NOTICE OF ADDENDUM
ADDENDUM 1
FOREST HILL CEMETERY- JOHN CATLIN CHAPEL ROOF REPLACEMENT
CONTRACT NO. 7478

FOREST HILL CEMETERY DIVISION 7 – THERMAL AND MOISTURE PROTECTION
JOHN CATLIN CHAPEL ROOF REPLACEMENT SECTION 07 31 26 – SLATE SHINGLES – REVISED
CONTRACT NO.: 7478

FOREST HILL CEMETERY - JOHN CATLIN CHAPEL
ROOF REPLACEMENT
CITY OF MADISON CONTRACT # 7478

ADDENDUM NO. 2 - 4/16/15

2 TOP OF TOWER VIEW
A6 SCALE: N.T.S.

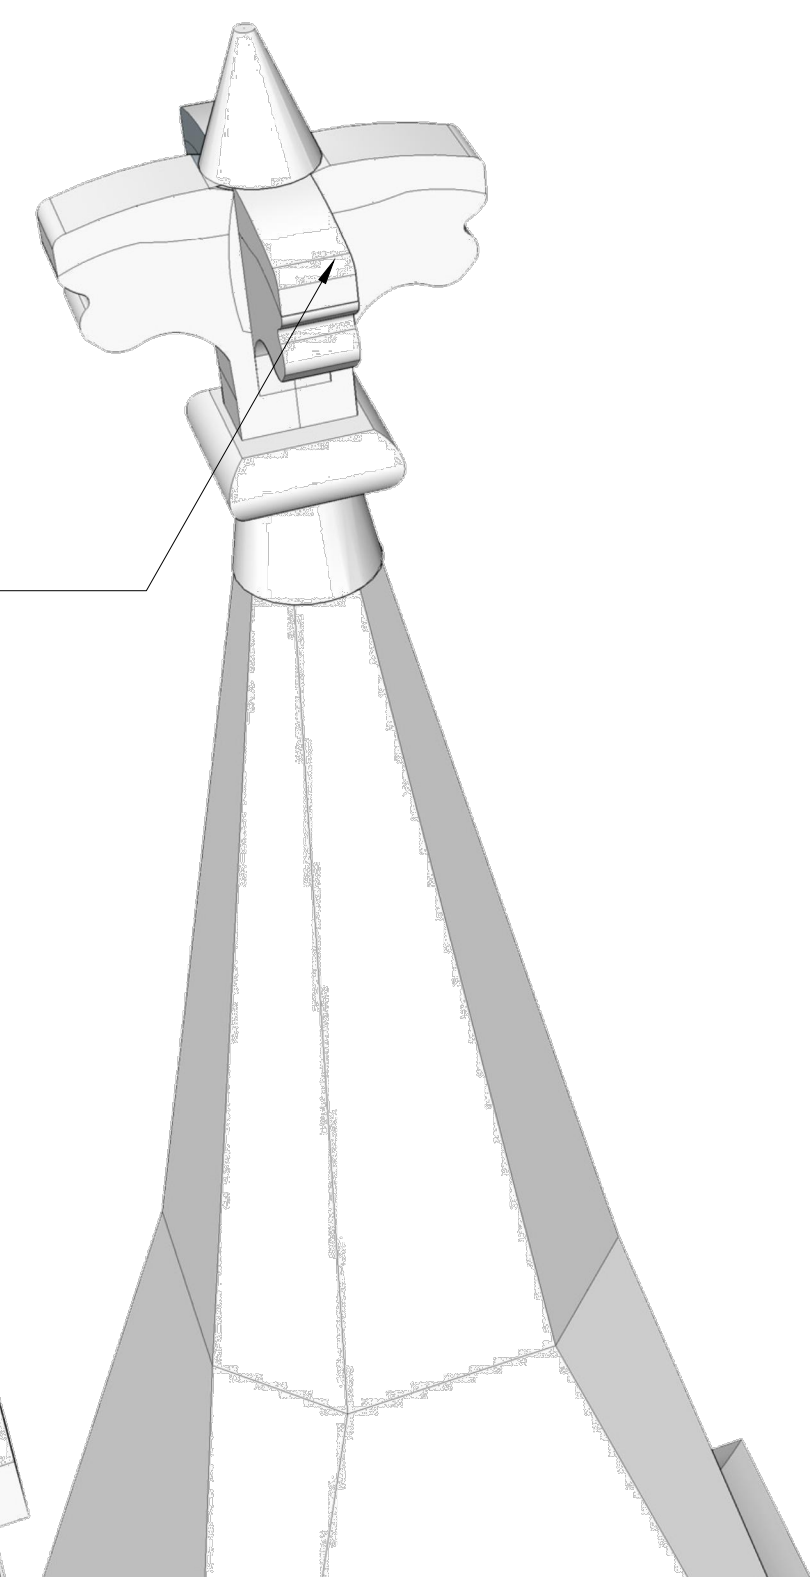
REMOVE EXISTING FINIAL AND STRIP ALL FINISHES TO BASE METAL USING THE GENTLEST METHOD POSSIBLE - COAT WITH 50% ZINC / 50% TIN ALLOY TO MATCH ADJACENT TERNE.

3 DETAIL AT GABLE / RAKE FLASHING
A6 SCALE: 6" = 1'-0"

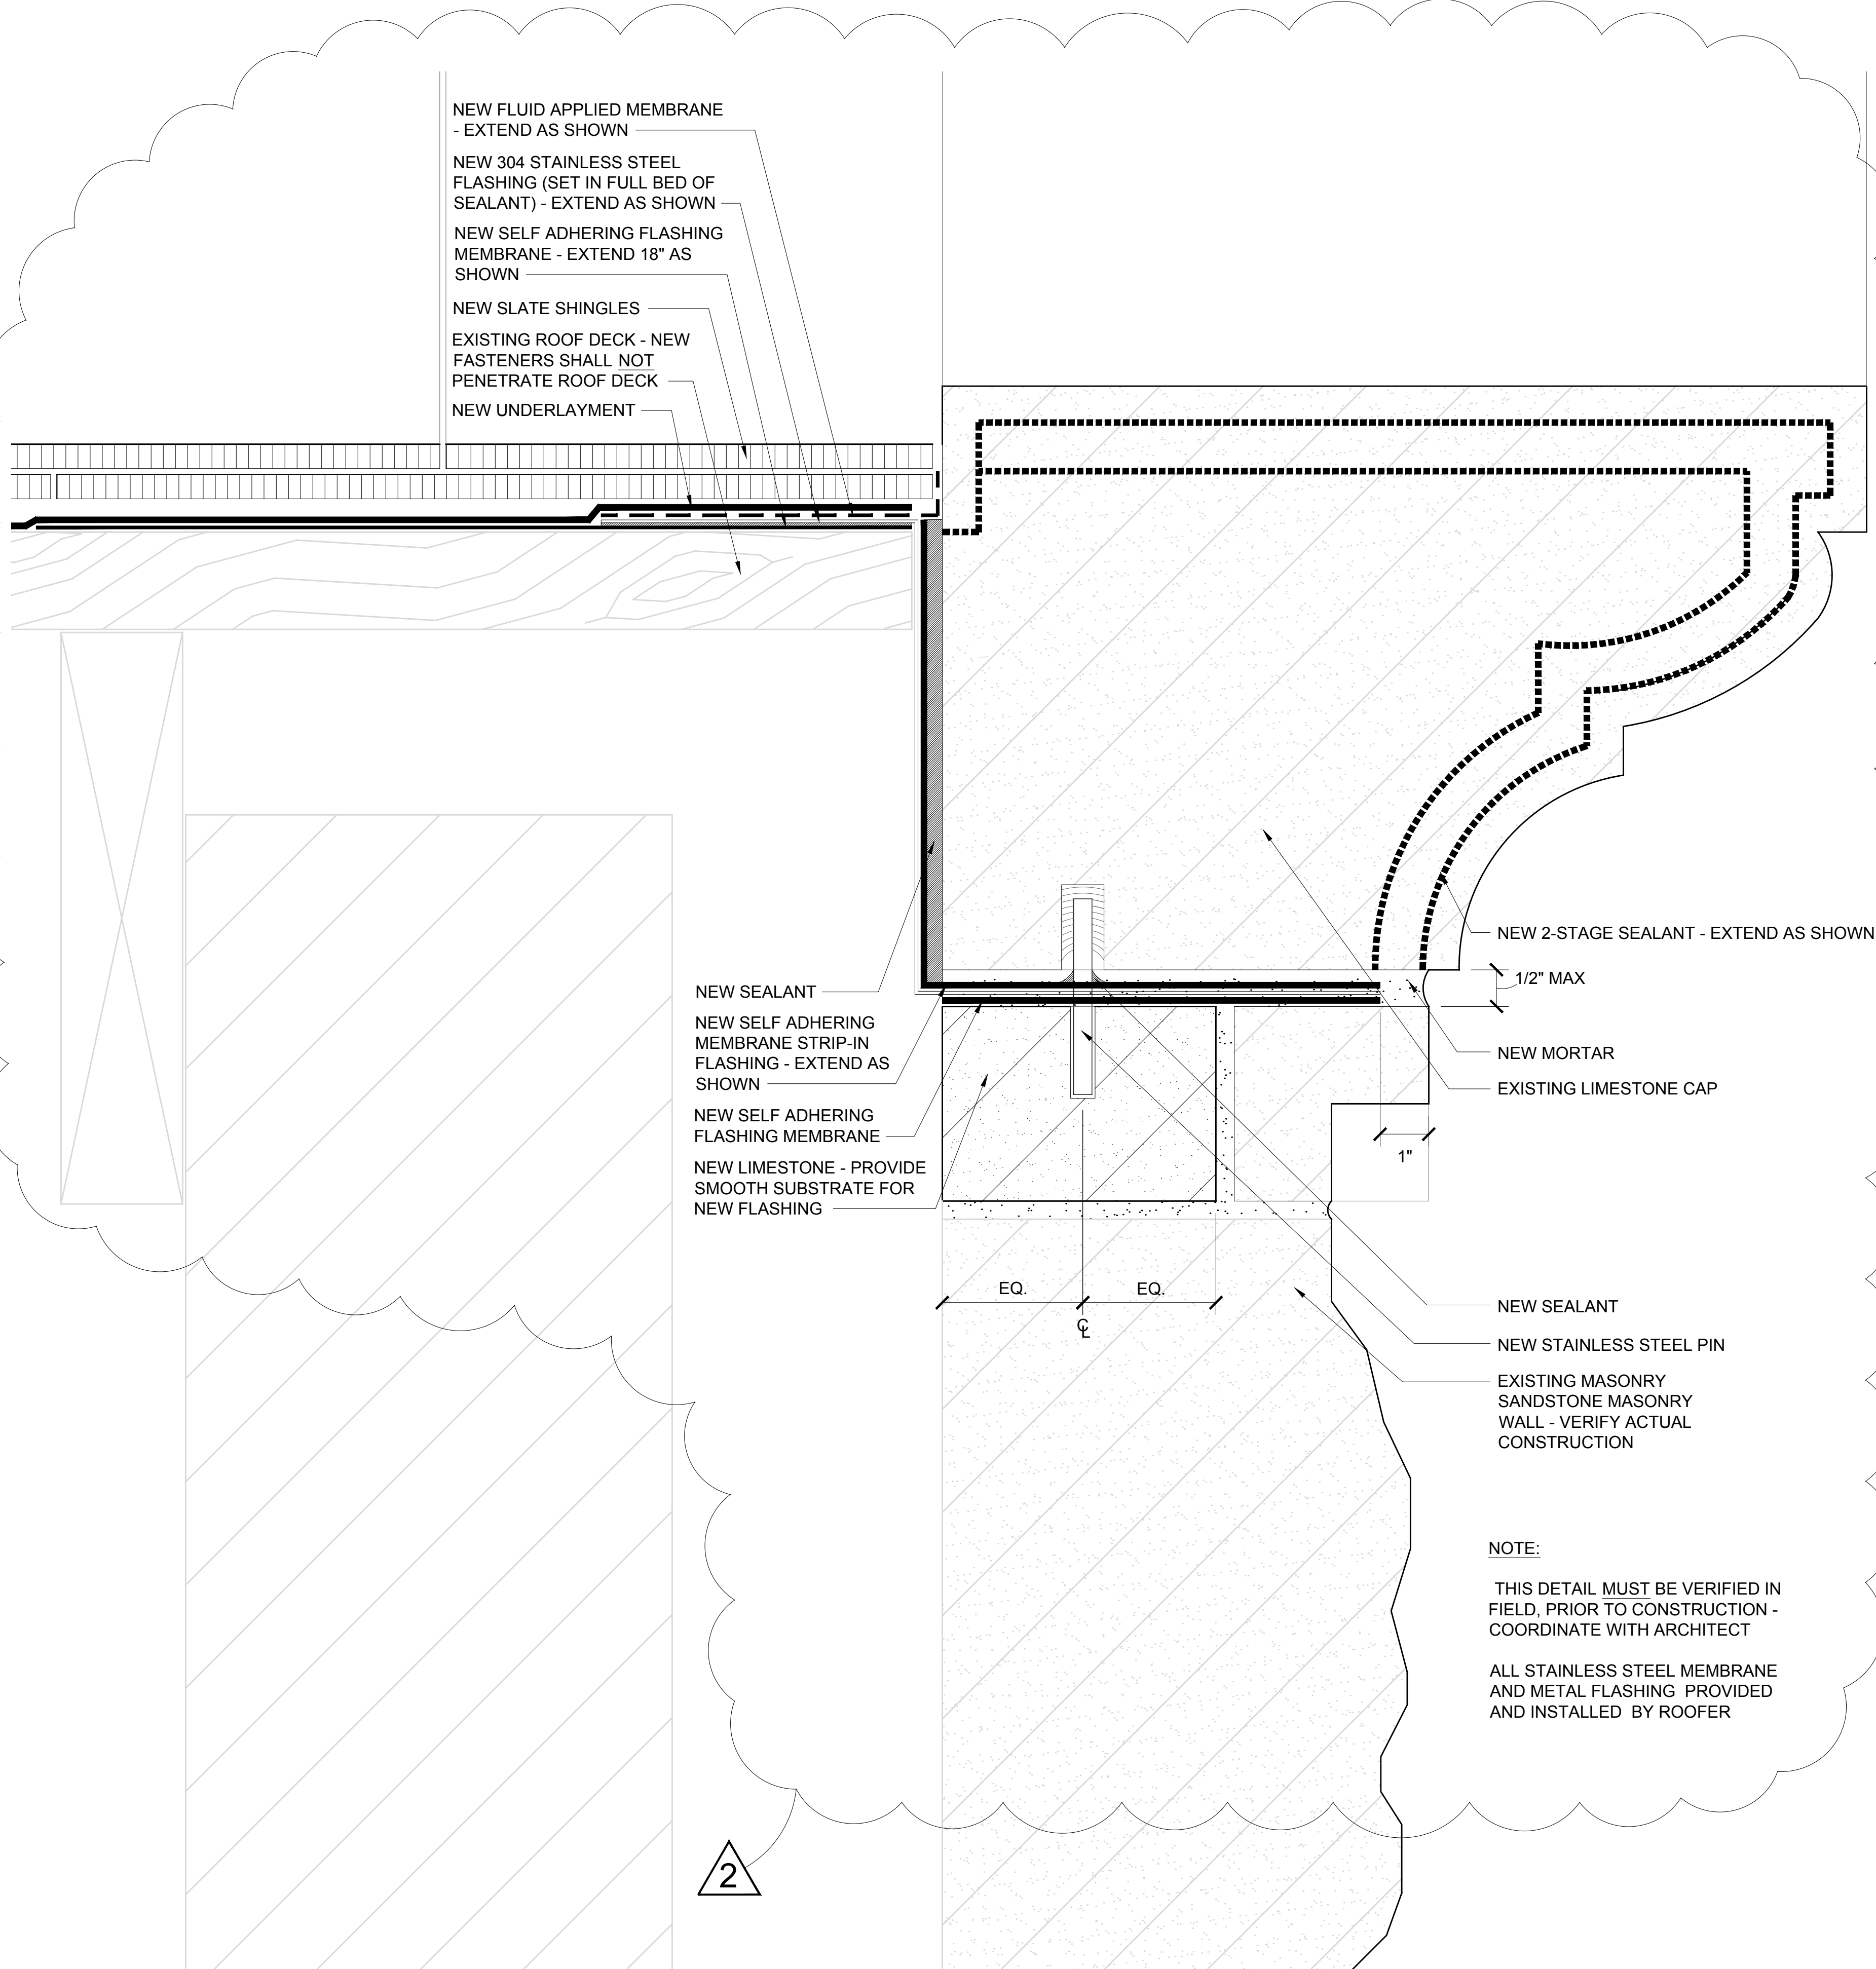
1. SHEET A6: Amend drawing sheet A6 as indicated on revised drawing sheet A6, see attached.
Please acknowledge this addendum on page E1 of the contract documents and/or in Section E: Bidder's

NEW FLUID APPLIED MEMBRANE - EXTEND AS SHOWN
NEW 304 STAINLESS STEEL FLASHING (SET IN FULL BED OF SEALANT) - EXTEND AS SHOWN
NEW SELF ADHERING FLASHING MEMBRANE - EXTEND 18" AS SHOWN
NEW SLATE SHINGLES
EXISTING ROOF DECK - NEW FASTENERS SHALL NOT PENETRATE ROOF DECK
NEW UNDERLAYMENT

NEW SEALANT
NEW SELF ADHERING MEMBRANE STRIP-IN FLASHING - EXTEND AS SHOWN
NEW SELF ADHERING FLASHING MEMBRANE
NEW LIMESTONE - PROVIDE SMOOTH SUBSTRATE FOR NEW FLASHING

NEW 2-STAGE SEALANT - EXTEND AS SHOWN
1/2" MAX
NEW MORTAR
EXISTING LIMESTONE CAP

NEW SEALANT
NEW STAINLESS STEEL PIN
EXISTING MASONRY SANDSTONE MASONRY WALL - VERIFY ACTUAL CONSTRUCTION

NOTE:
THIS DETAIL MUST BE VERIFIED IN FIELD, PRIOR TO CONSTRUCTION - COORDINATE WITH ARCHITECT
ALL STAINLESS STEEL MEMBRANE AND METAL FLASHING PROVIDED AND INSTALLED BY ROOFER
